Our Ref: SK/I0843/sk

16 March, 2018

RE: PROPOSED RESIDENTIAL DEVELOPMENT AT 1A AND 1B QUEEN STREET, AUBURN

1. As requested, we are writing to respond to matters raised by council in relation to the above development. We have previously prepared a traffic report⁽¹⁾ which was submitted as part of the development application (DA-382/0217).

COMPLIANCE CHECK
AS2890.1-2004 & AS2890.2-2002

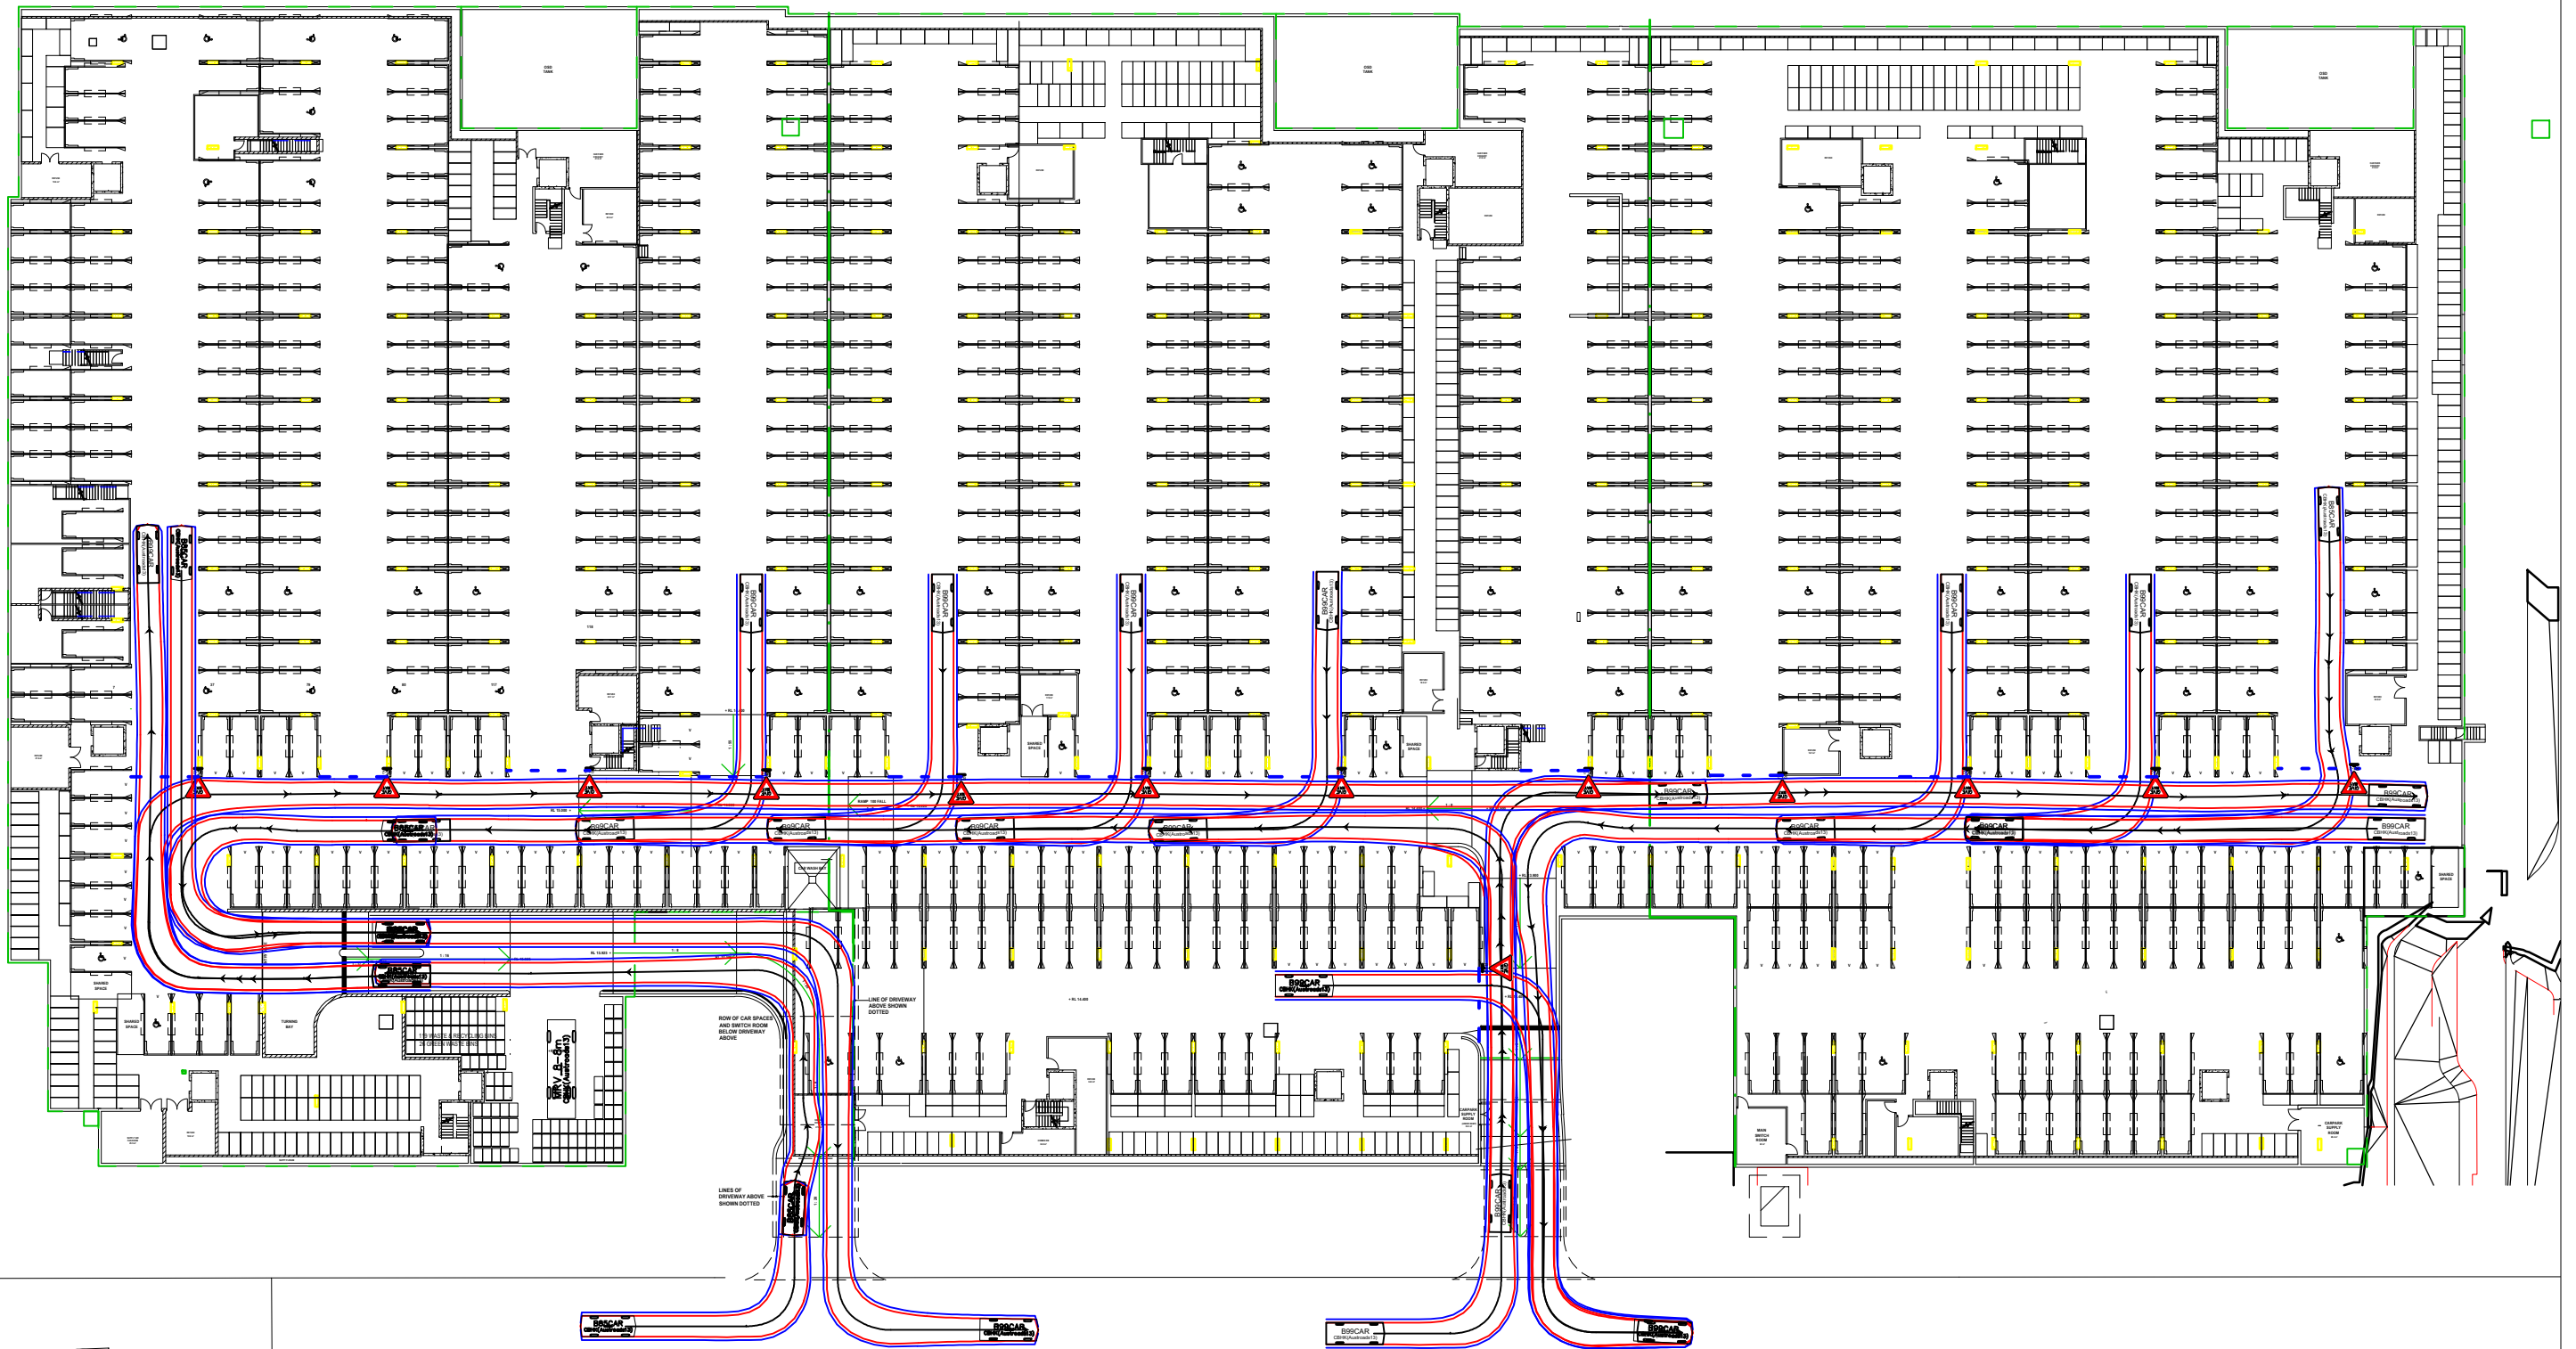
- *Visitor parking spaces shall be annotated on the plan. Width of the visitor parking spaces shall be minimum 2.6m. Turning area shall be provided in accordance with Australian standard requirements, if visitor parking spaces located in the blind aisles.*

7. In accordance with the Australian Standard, residential visitor parking spaces are User Class 2 parking spaces and are required to be provided with minimum dimension of 2.5 metres wide by 5.4 metres long and aisle widths of 5.8 metres. Visitor parking, as shown on plans prepared by AJ+C

14. In accordance with the Australian Standards, parking spaces will be provided at 2.4 metres by 5.4 metres long for residential tenant spaces and 2.5 metres wide by 5.4 metres long for visitor spaces. Spaces located adjacent to structure will be 300mm wider to allow for door opening, and columns will be set back 750mm from the front of the space. Access to car parking spaces will be provided from 5.8 to 6.4 metre wide circulation aisles. Dead end aisles will incorporate a one metre extension to allow appropriate access to end parking bays.

6. Residential visitor spaces in basement car parks typically have the same dimensions as residential spaces, due to the constraints of column grids. For this development wider visitor spaces at 2.5 metres wide are provided. This width satisfies the requirement of User Class 2 (medium turnover parking), as set out in the Australian Standard AS2890.1-2004. The requirement for 2.6 metre wide parking spaces (User Class 3) is not appropriate for residential visitor parking spaces as this requirement is for short term, high turnover parking.

8. As shown on plans prepared by AJ+C Architects, no visitor parking spaces will be located in blind aisles. Visitor parking will be located along the main western circulation aisle.

B85 & B99 VEHICLE SWEPT PATHS

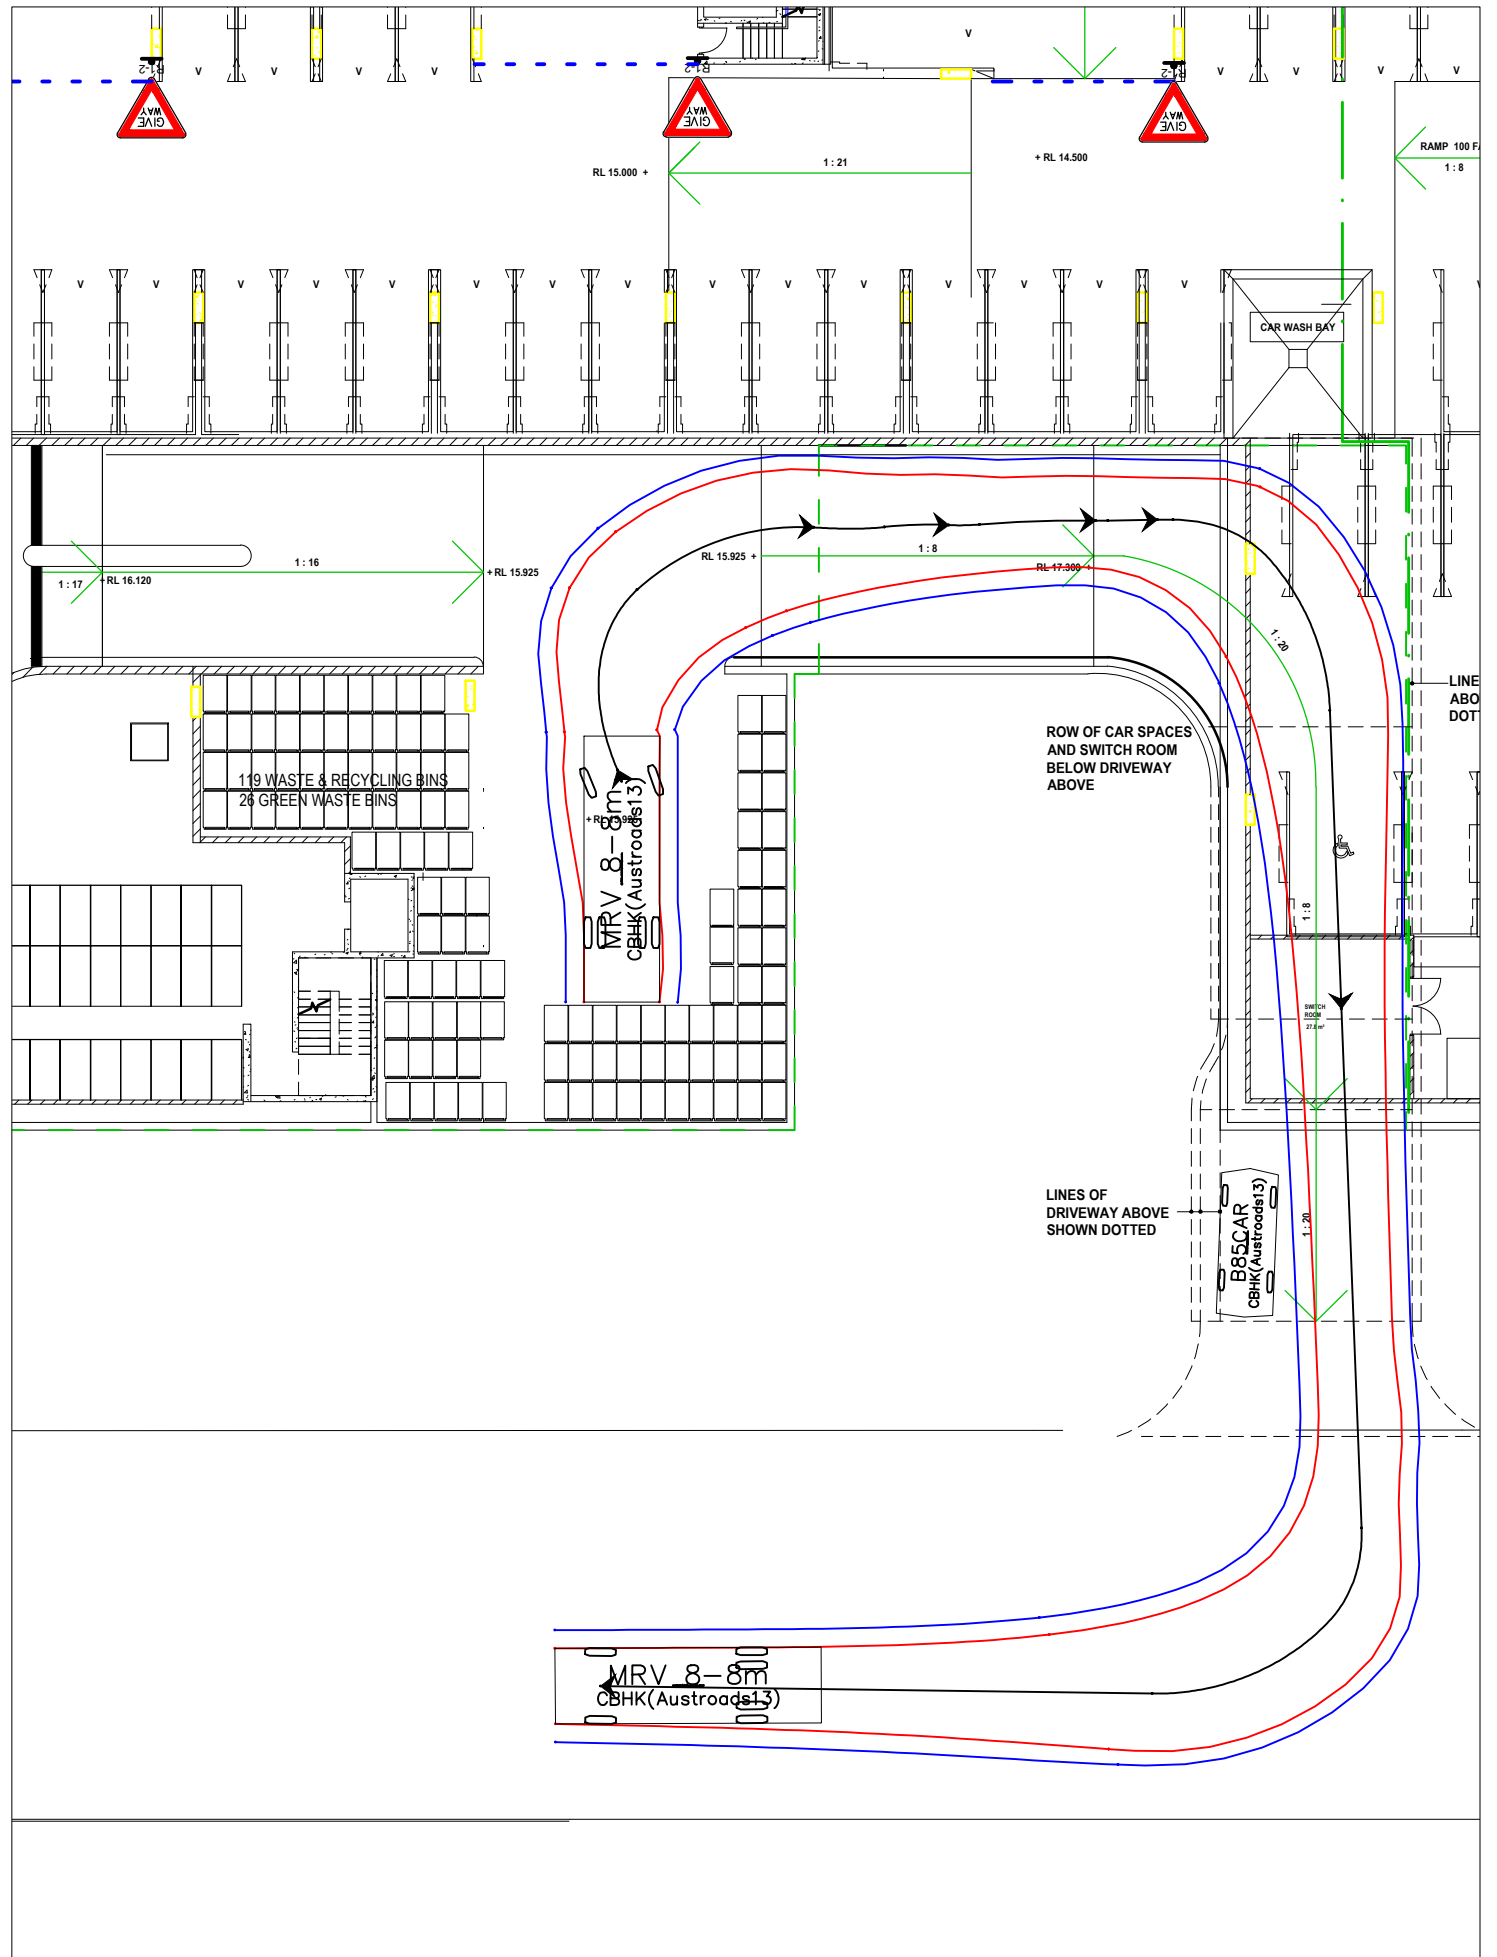
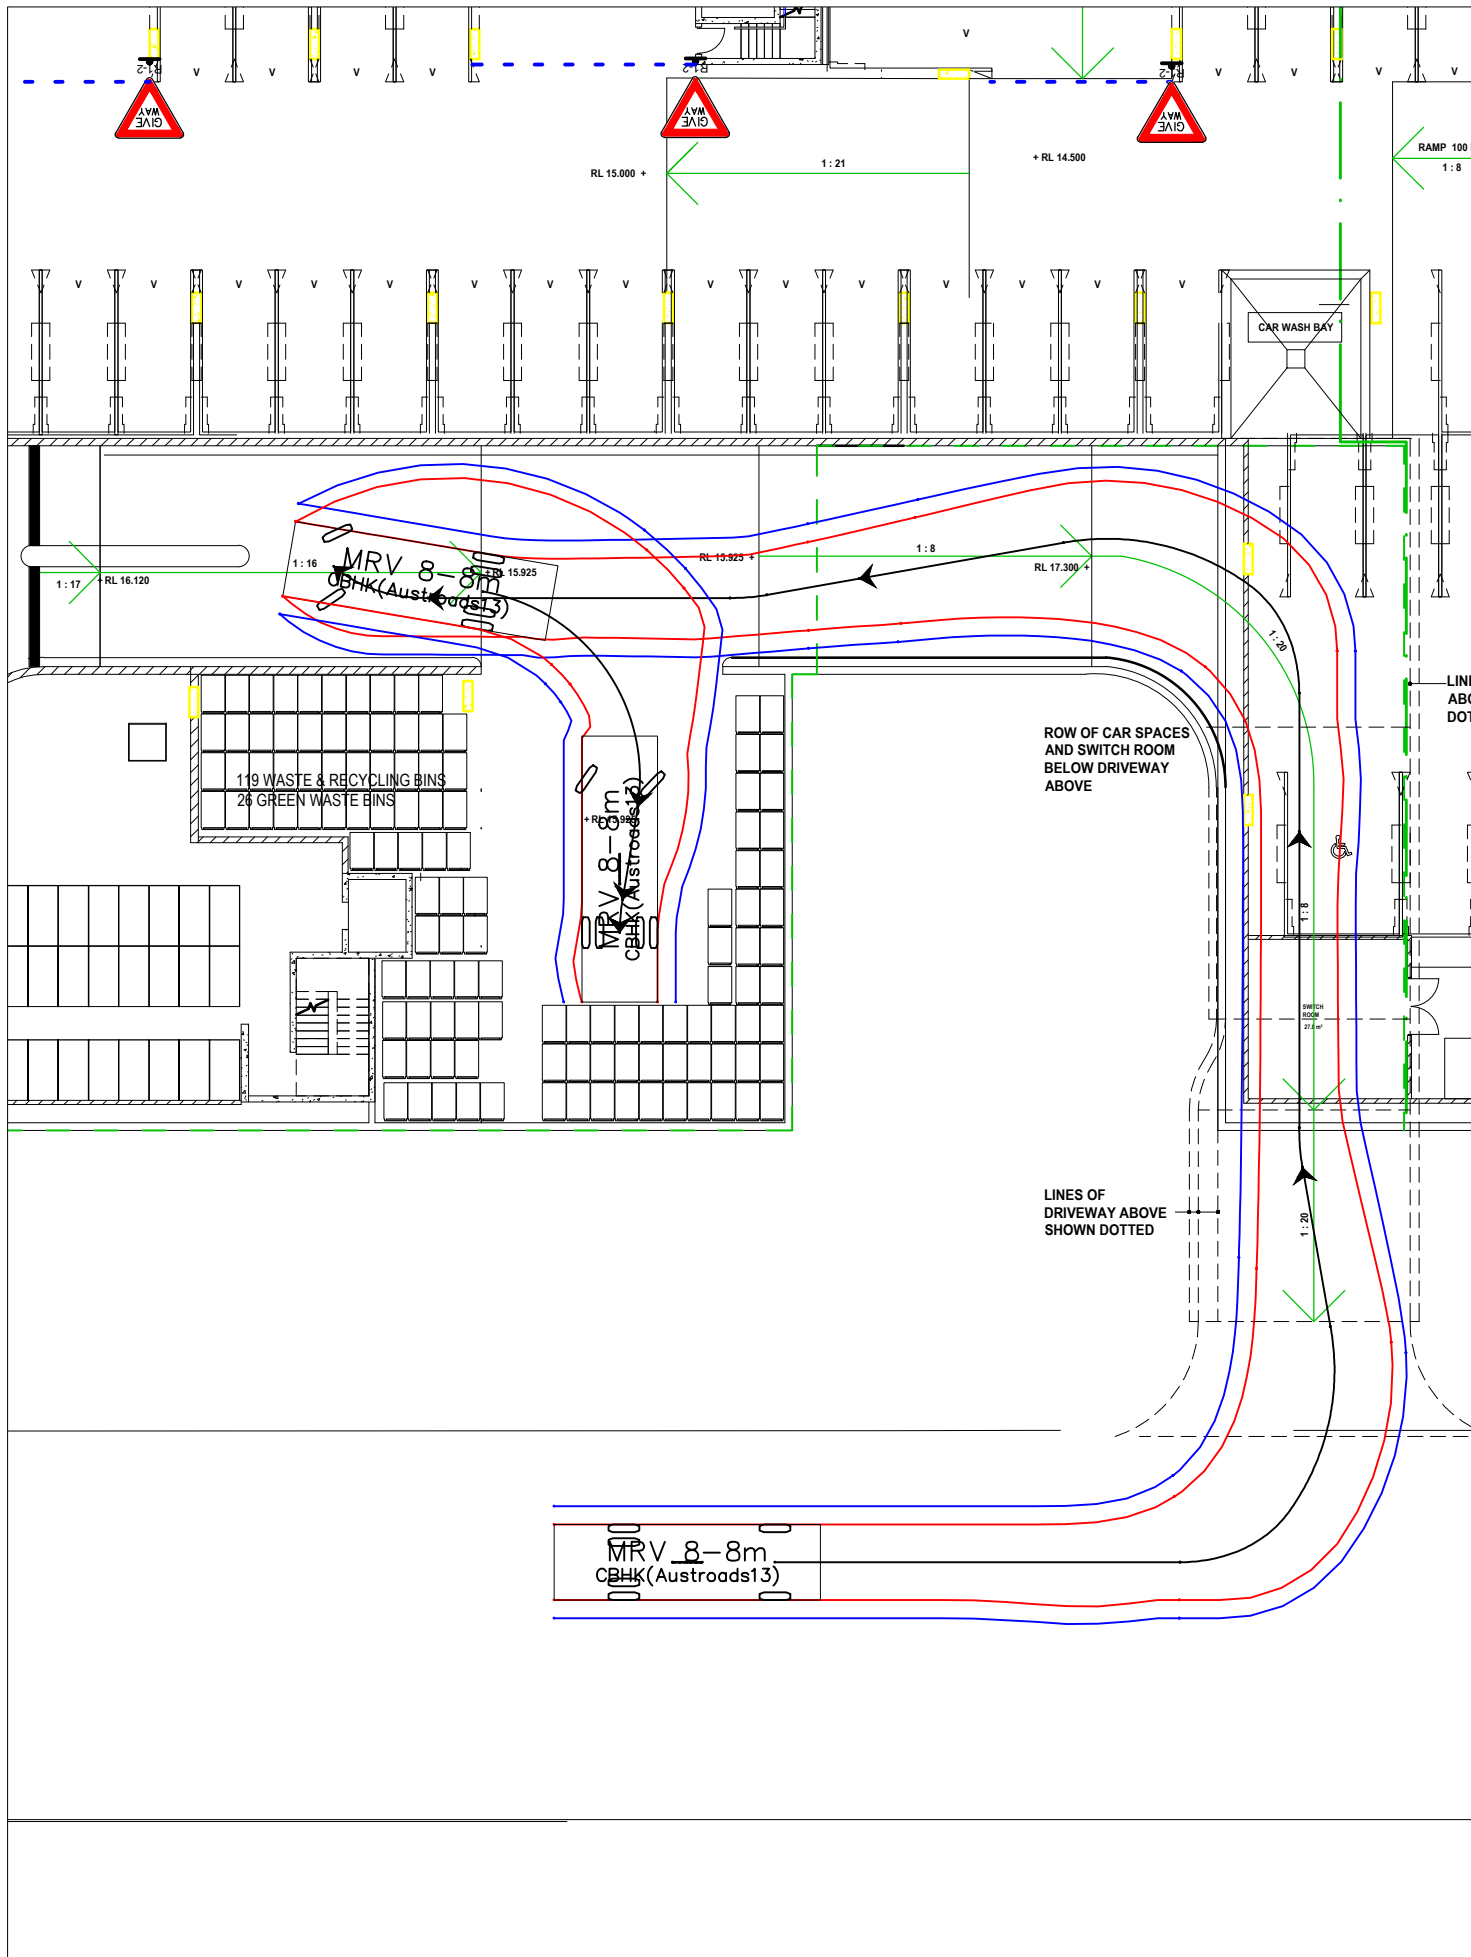
- *Curved roadways/ramps shall comply with the Section 2.5 of the Australian standard AS2890.1. In this regard, ramp widths shall comply with Table 2.2 of the Australian standard AS2890. 1.*

- *A separator or median shall be provided in the curved roadway/ramp where radius of outer curve is less than 15m.*
12. As discussed in paragraph 10, the bend in the car park access should allow a B85 and a B99 vehicle to pass, as demonstrated in Figure 2 attached. A separator or median is therefore not required.

- *The intersection of the basement aisles and the access ramps shall be designed such a way that B99 and B85 vehicles can pass each other safely to comply with Clause 2.5.2 (c). In this regard swept path analysis shall be provided.*

11. Application of the design requirements set out in Table 2.2 of AS2890.1-2004 are not appropriate at this location as the design criteria is to allow two cars to pass in a satisfactory manner. In this regard the bend in the car park access, at the northern access driveway, should comply with clause 2.5.2 (c) which requires a B85 and a B99 vehicle to pass, as demonstrated with vehicle swept paths shown in Figure 2 attached.

17. Swept paths shown on Figure 2 show that a B85 and a B99 vehicle can comfortably pass each other within the car park. Intersections within the car park will be controlled by Give Way signs. These arrangements are in accordance with the Australian Standards and are considered appropriate.
